Entergy Arkansas, Inc. 2018 Integrated Resource Plan

Follow-Up Materials
June 18, 2018
entergy-arkansas.com/IRP

Follow-up Materials to the 2018 IRP Stakeholder Meeting

FOLLOW-UP MATERIALS - RESPONSE SET 3

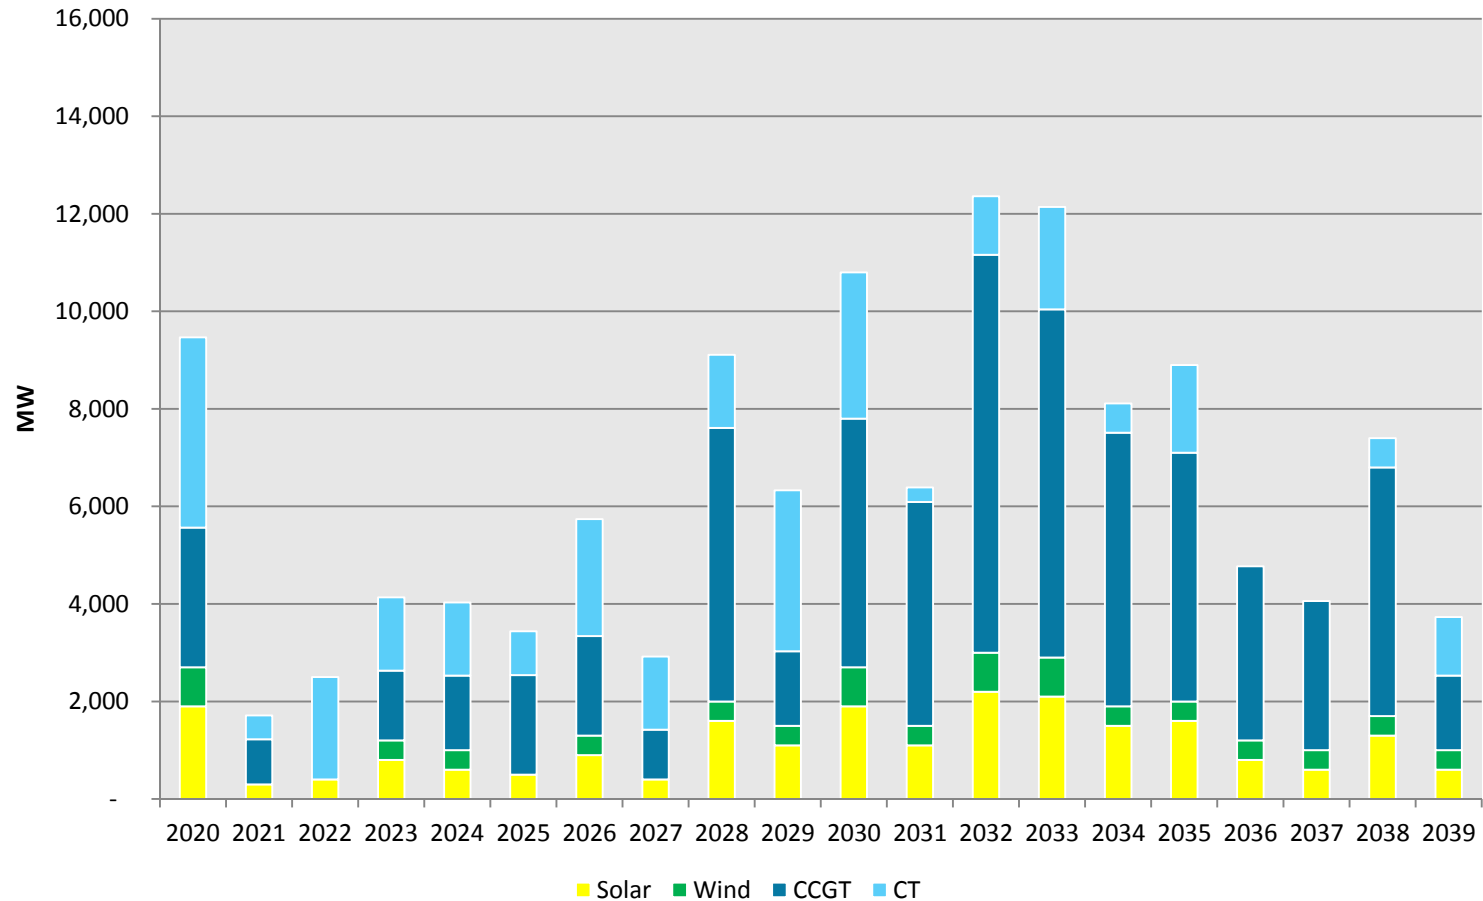
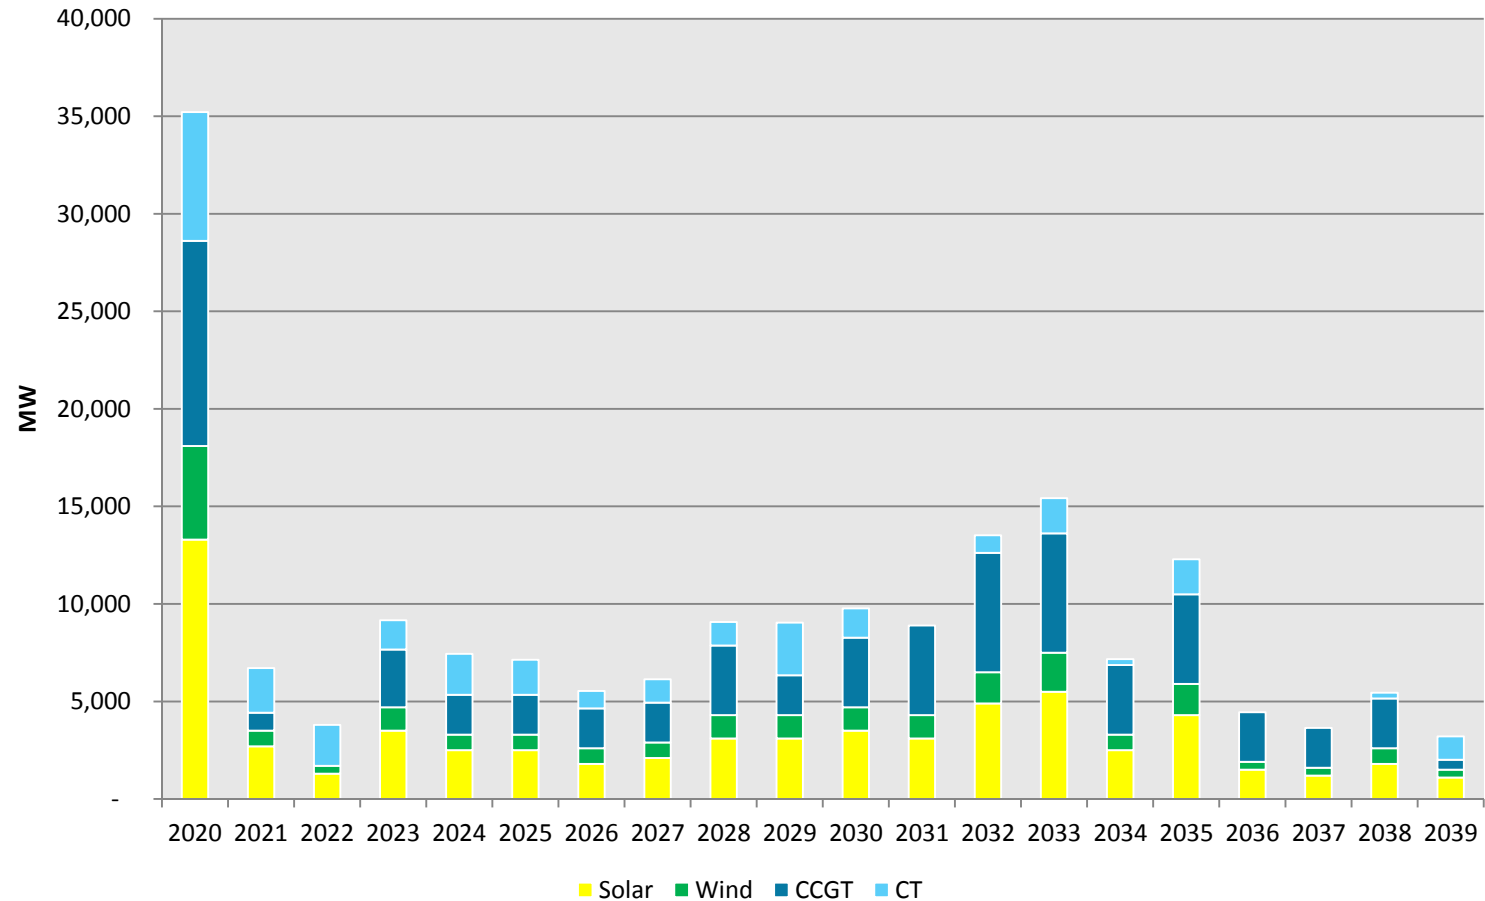
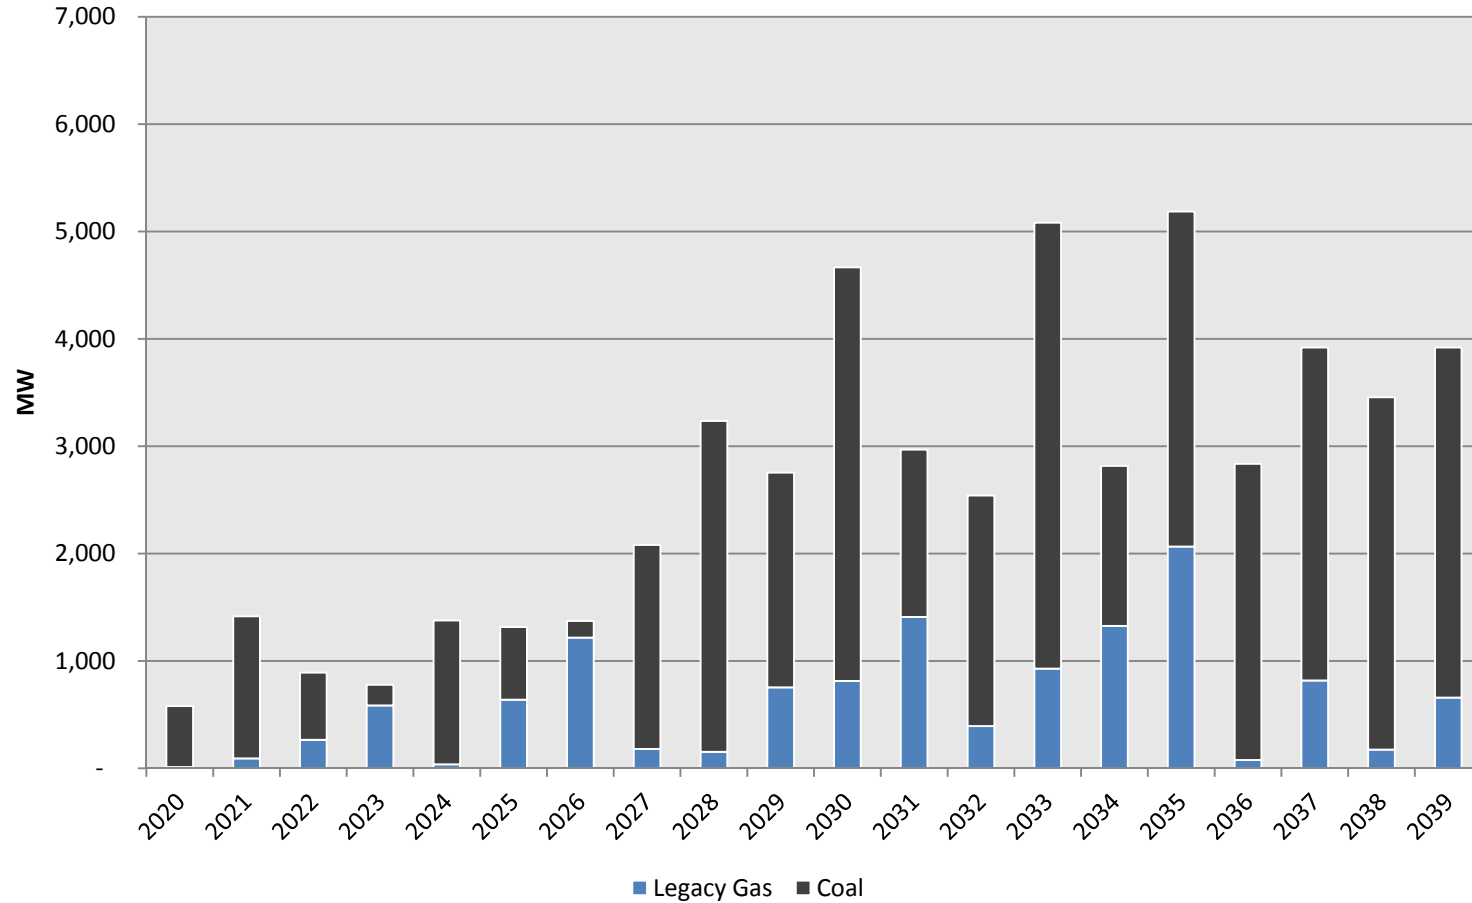
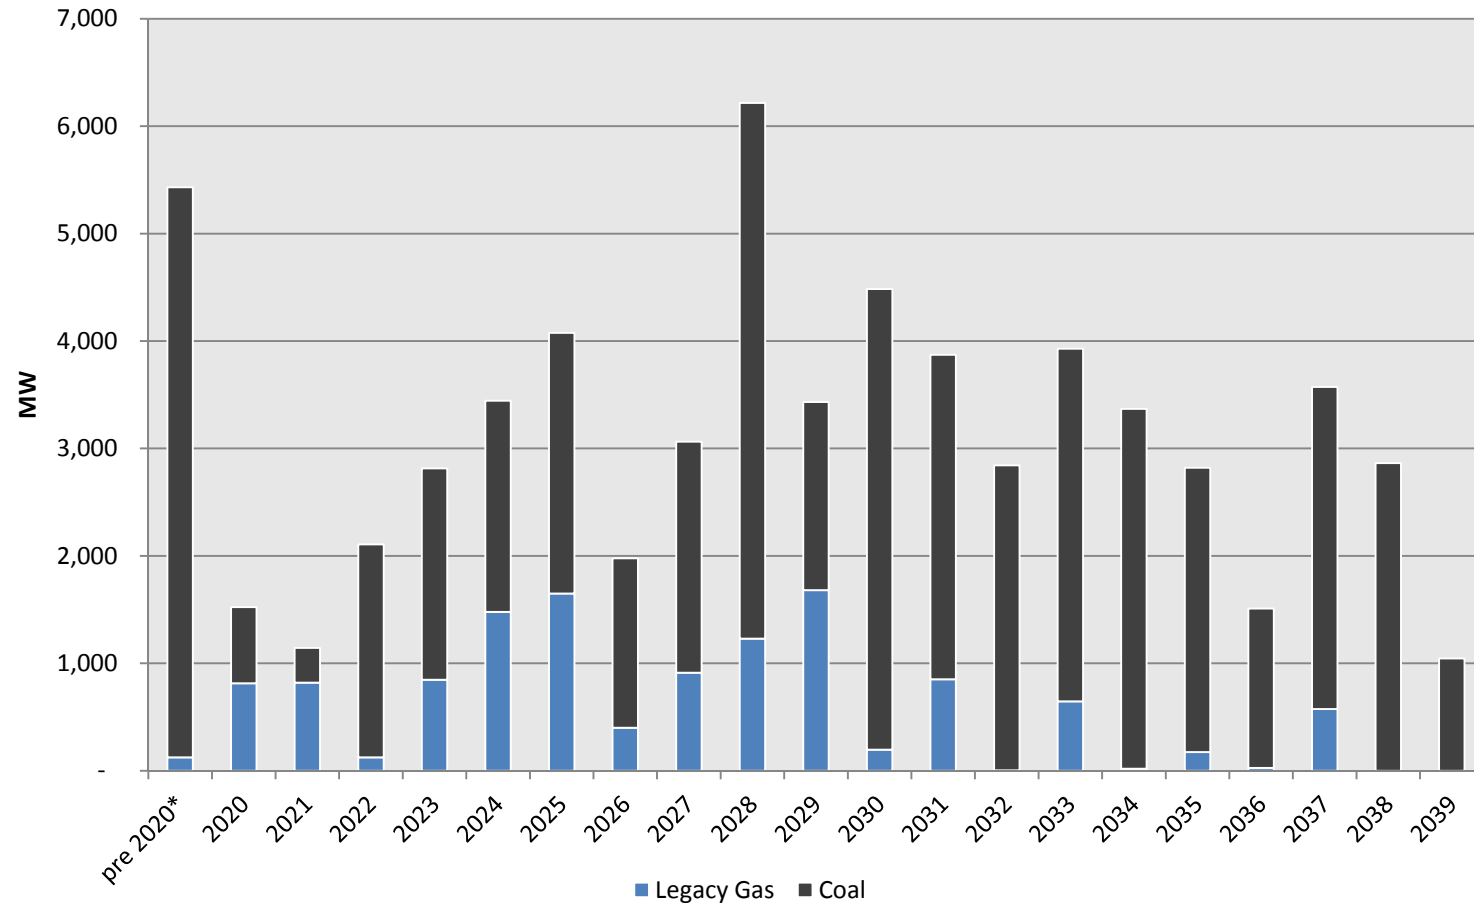
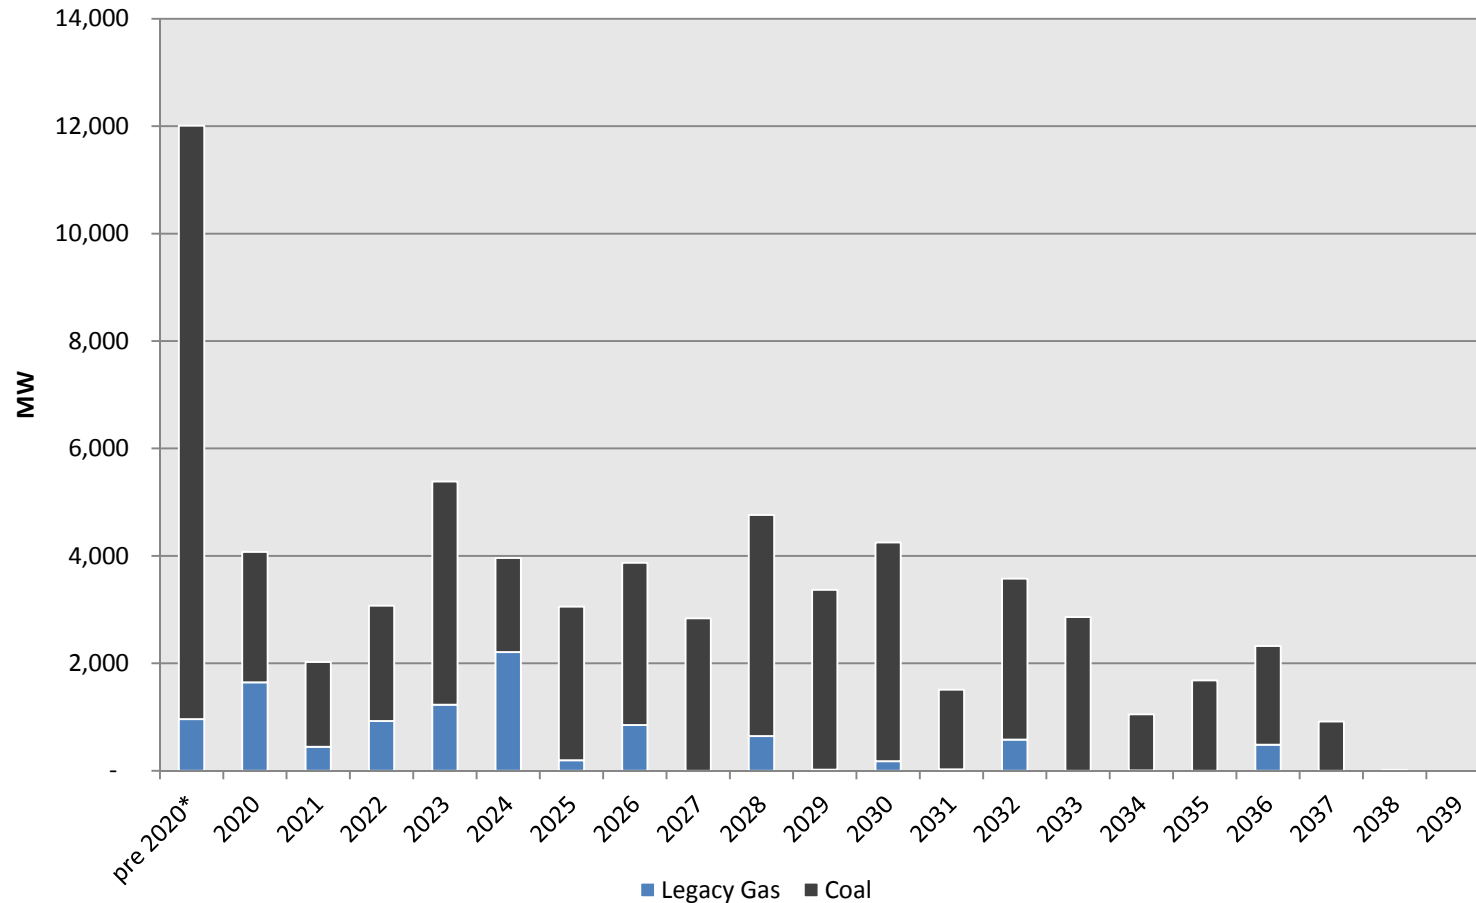
- Provide MW values of market coal/gas deactivations, and MW values of incremental market resources, including on a unit level (Slide 80).
 - Refer to the charts on the following slides:
 - Reference Future Market Additions
 - Low Future Market Additions
 - High Future Market Additions
 - Reference Future Market Deactivations
 - Low Future Market Deactivations
 - High Future Market Deactivations

**MISO Market (Non-EAI) Incremental Additions
Low Future (55 Year Life)**

**MISO Market (Non-EAI) Incremental Additions
High Future (50 Year Life)**

MISO Market (Non-EAI) Legacy Gas and Coal Unit Deactivations
Reference Future (60 Year Life)

**MISO Market (Non-EAI) Legacy Gas and Coal Unit Deactivations
Low Future (55 Year Life)**

**MISO Market (Non-EAI) Legacy Gas and Coal Unit Deactivations
High Future (50 Year Life)**

Slide 69 - Renewable Resource Assumptions (Solar PV & Wind)

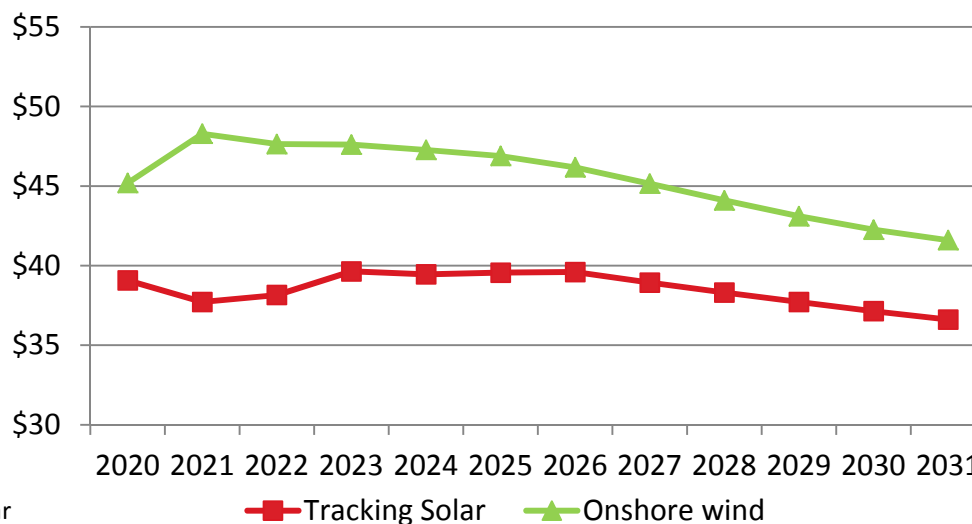
EAI committed to providing updates to the Levelized Real Cost values for Renewables and Battery Resources on Slides 69-70 of the Stakeholder Materials from June 6th. Refer to the following two slides for these updates.

- Follow-Up Materials - Set 2, Slide 17 Update:
 - What is EAI's assumed capital cost on Slide 69?
 - Given that the data requested is vendor produced and commercially sensitive, EAI requested permission from IHS Markit and received the following response:
 - "The capital cost assumptions are based on a confidential IHS Markit forecast. The costs are assumed to be near the \$1/W-DC range and the trend reflects a steadily decreasing cost and increasing efficiency for solar panels throughout the study period (2020 – 2039)."

2020	2021	2022	2023	2024	2025	2026	2027	2028	2029	2030	2031
Solar Tracking ²	\$39	\$38	\$38	\$40	\$39	\$40	\$40	\$39	\$38	\$38	\$37	\$37
Onshore Wind ³	\$45	\$48	\$48	\$48	\$47	\$47	\$46	\$45	\$44	\$43	\$42	\$42

Solar	Wind
Fixed O&M (2017\$/kW-yr-AC)	\$16	\$23.46
Useful Life (yr)	30	25
MACRS Depreciation (yr)	5	5
Capacity Factor	26%	41%
DC:AC	1.35	N/A
Hourly Profile Modeling Software	PlantPredict	NREL SAM
